**VIRGINIA ELECTRIC AND POWER COMPANY**  
**SURRY POWER STATION UNITS 1 AND 2**  
**APPLICATION TO ADOPT 10 CFR 50.69, "RISK-INFORMED CATEGORIZATION**  
**AND TREATMENT OF STRUCTURES, SYSTEMS AND COMPONENTS FOR**  
**NUCLEAR POWER REACTORS"**  
**RESPONSE TO REQUEST FOR ADDITIONAL INFORMATION**

**RESPONSE TO NRC REQUEST FOR ADDITIONAL INFORMATION REGARDING  
LICENSE AMENDMENT REQUEST TO ADOPT 10 CFR 50.69**

**Virginia Electric and Power Company  
(Dominion Energy Virginia)  
Surry Power Station Units 1 and 2**

**Figure 3-1: Categorization Process Overview**

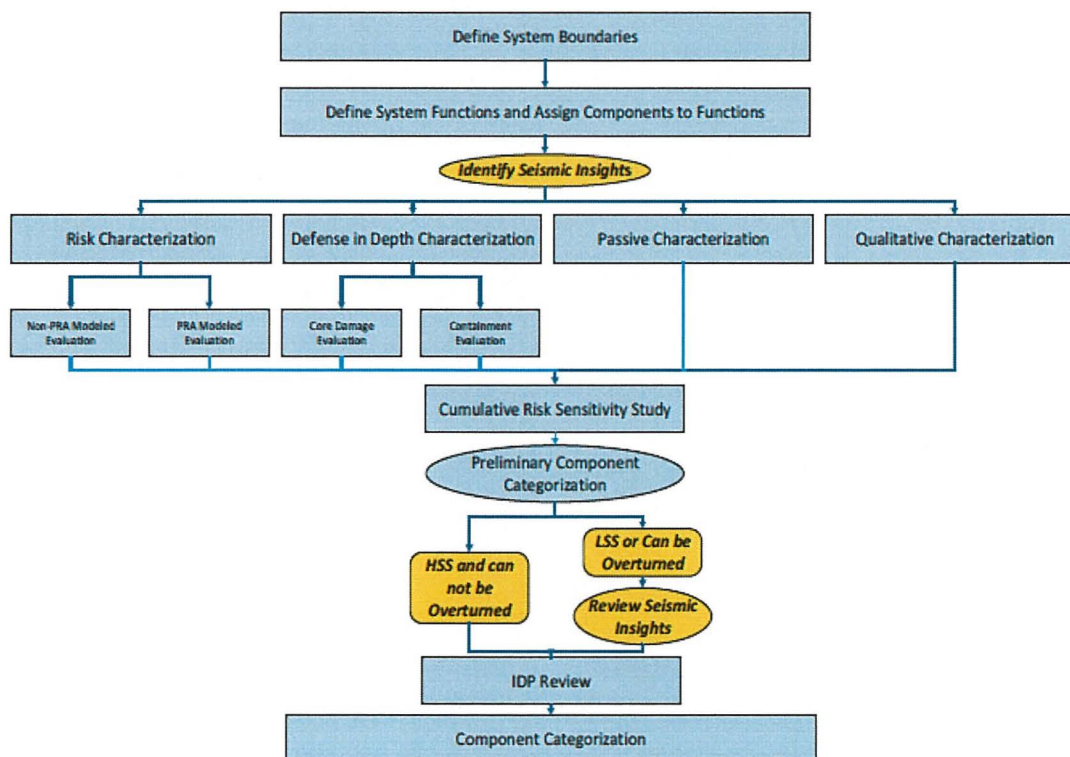
contribution of each system. Lastly, Figures 1-2 and 2-1 of NEI 00-04 indicate that the risk sensitivity study should be provided to the IDP prior to SSC categorization.

Section 3.1.1 of the LAR states that “[t]he order in which each of the elements of the categorization process (listed below) is completed is flexible, and, as long as they are all completed, they may even be performed in parallel.” For certain elements, this does not appear to be the case (i.e., many of the elements must be completed prior to the IDP review). LAR Figure 3-1, “Categorization Process Overview,” depicts the cumulative risk sensitivity study following the IDP review. However, based on the above discussion, it seems this sensitivity study should appear before the IDP review in LAR Figure 3-1. Thus, the licensee is requested to confirm whether or not the IDP review will consider information from the cumulative risk sensitivity study. If the IDP review will not consider this information, provide a detailed justification as to why the IDP review does not need to consider information from the cumulative risk sensitivity study, and how the requirements of 10 CFR 50.69 are met by the overall process depicted in LAR Figure 3-1.

The IDP will consider information from the cumulative risk sensitivity study. In the LAR for Surry Power Station, Figure 3-1 was incorrect. It should be replaced with the following Figure 3-1:
